MOON RIVER 3

PROPOSED GENERAL ARRANGEMENT

Mr. A. G. Stermac,
Principal Foundation Engr.,
Foundation Section,
Materials & Research Division.
January 7, 1963.

FOUNDATION INVESTIGATION REPORT - BY
Geocon, Limited, Consulting Engineers,
Proposed Moon River Bridge and C.P.R.
Subway, Bala, Ontario, District No. 11.

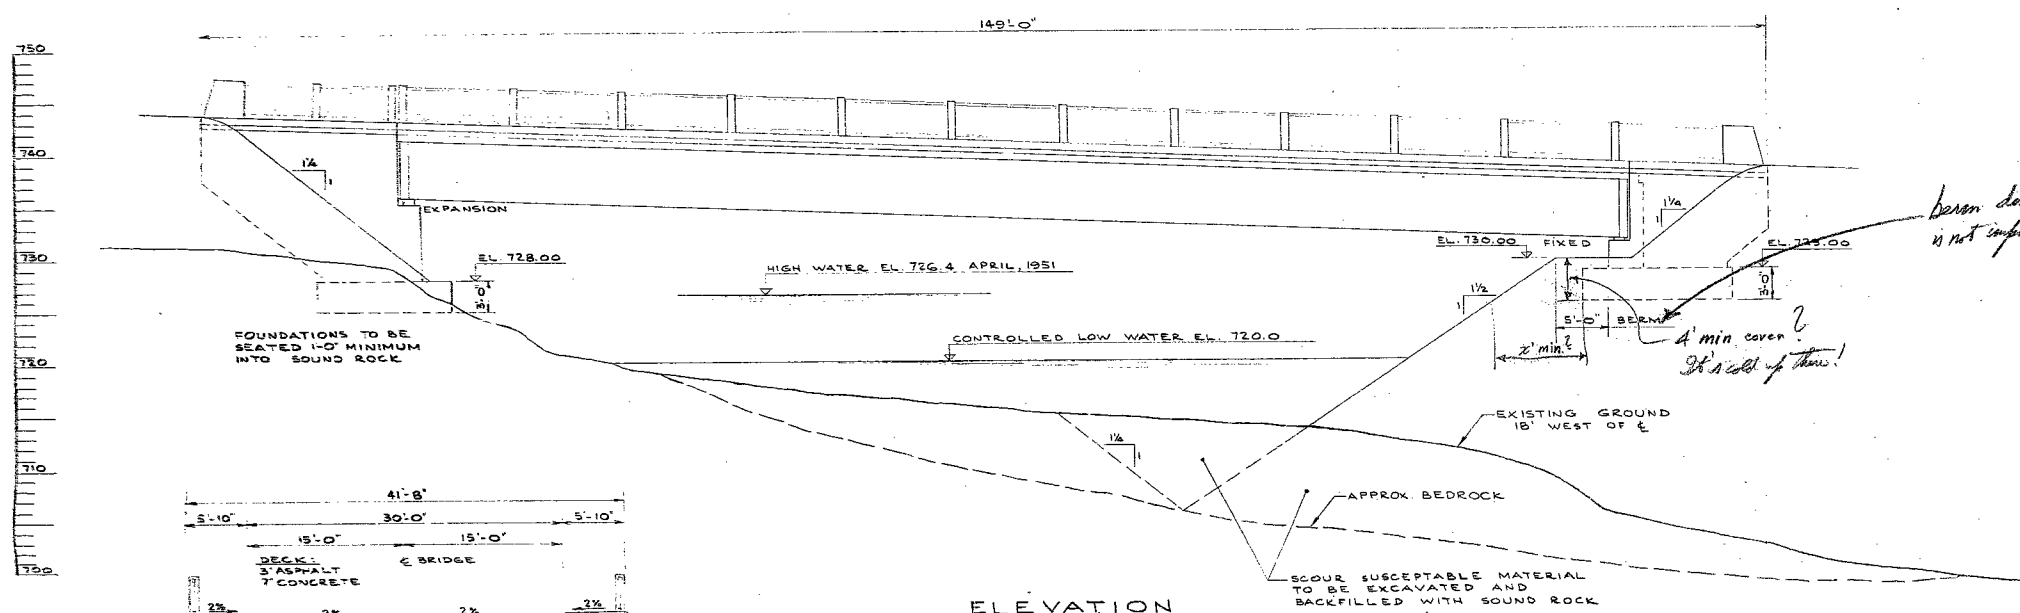
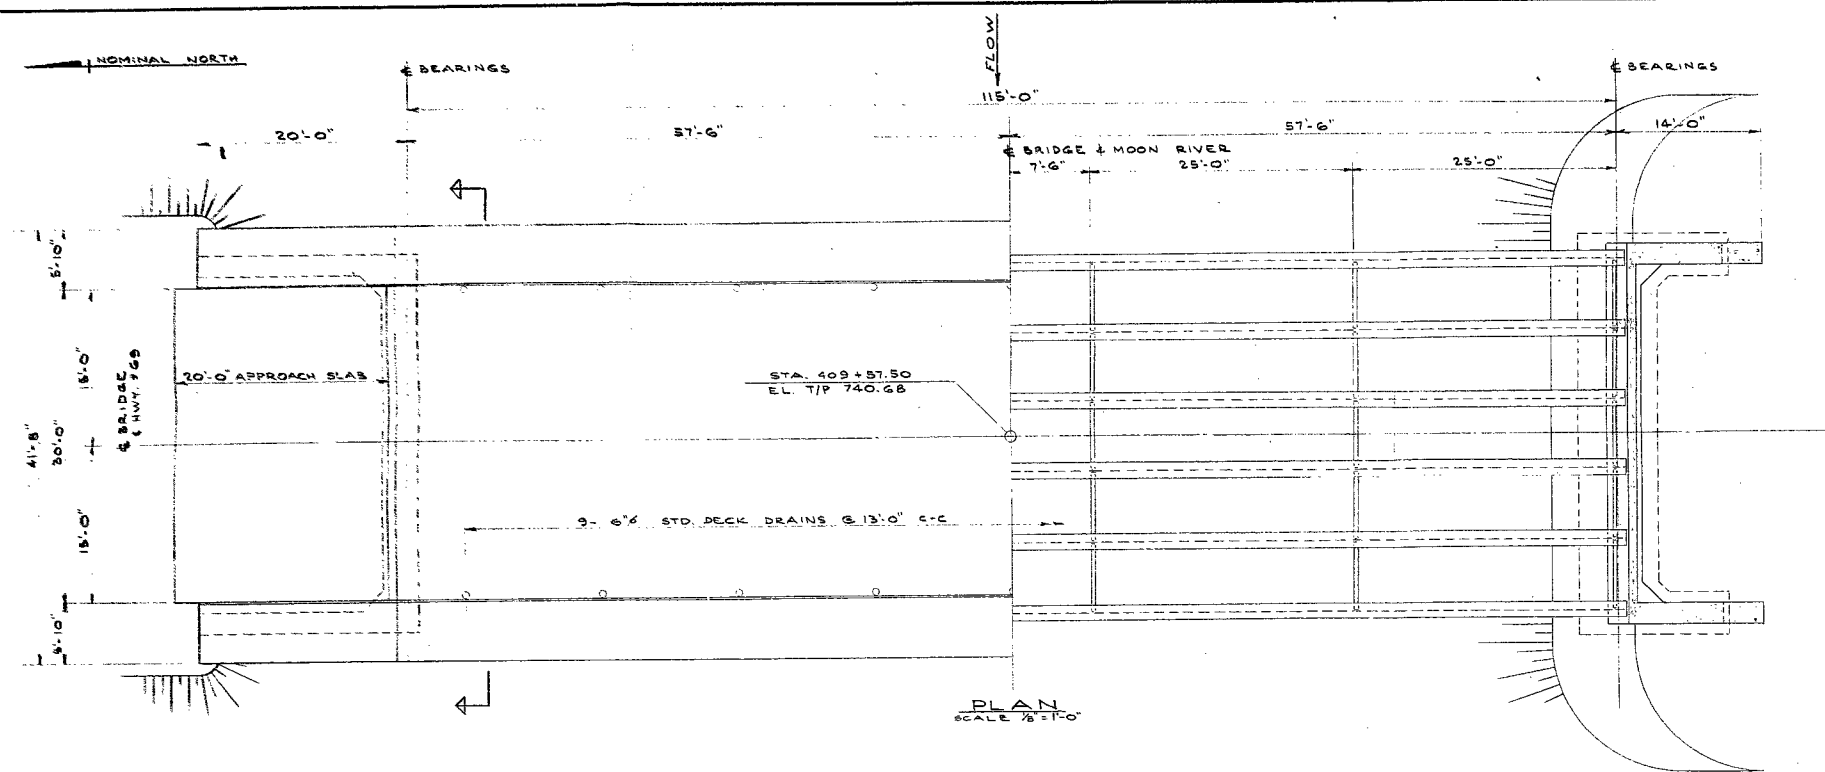
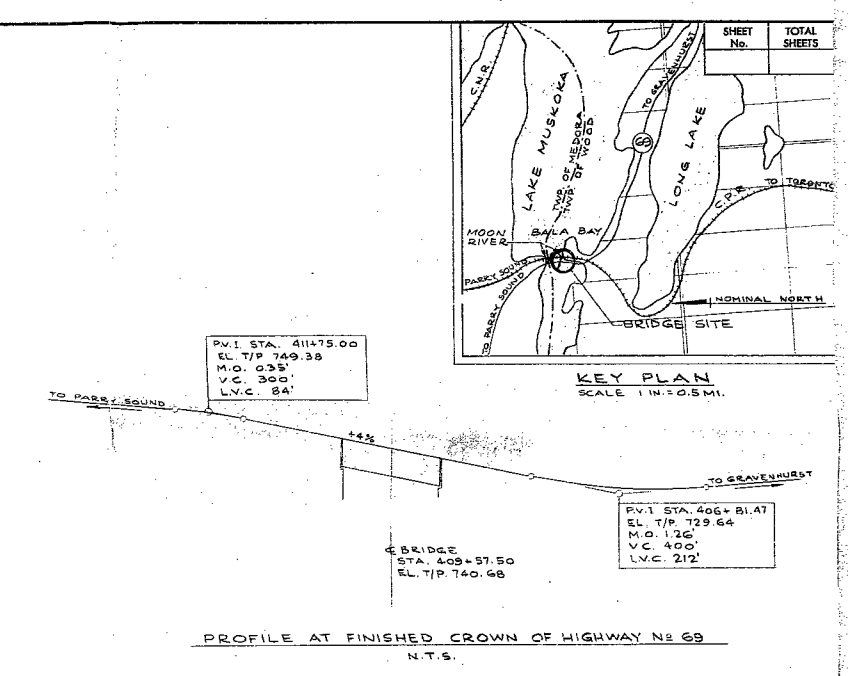
RECOMMENDATIONS BY FOUNDATION SECTION

1. DISTANCE OF LOWER EDGE OF FOOTING FROM SLOPE SHOULD BE 10 (TEN) FEET. (THIS VALUE IS BASED ON SLOPEHENT)
2. COVER ABOVE FOOTING BASE SHOULD BE FIVE FEET.
3. CARE SHOULD BE TAKEN WHEN EXCAVATION CARRIED OUT
